SILICON LABS
400 West Cesar Chavez
Austin, TX 78701

April 20,2017

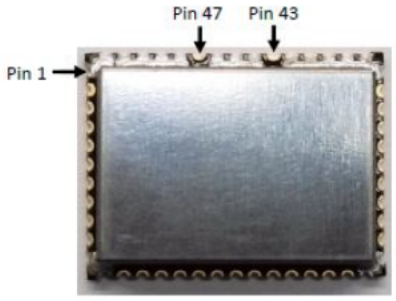
Module devices AMW006 and AMW106 from Silicon Labs have been shipped using 2 different marking label orientations. This may create confusion when trying to identify the pin 1 during orientation of the module and possible misorientation of the modules during surface mount.

There are two possible label orientations as described below. The location of pin 1 should always be determined by the antenna pins 47 and 43 which show as notches in surrounding soldered ground pins.

All shipments after 20 April 2017 will carry the Standard Label Orientation to help avoid any confusion in the future.
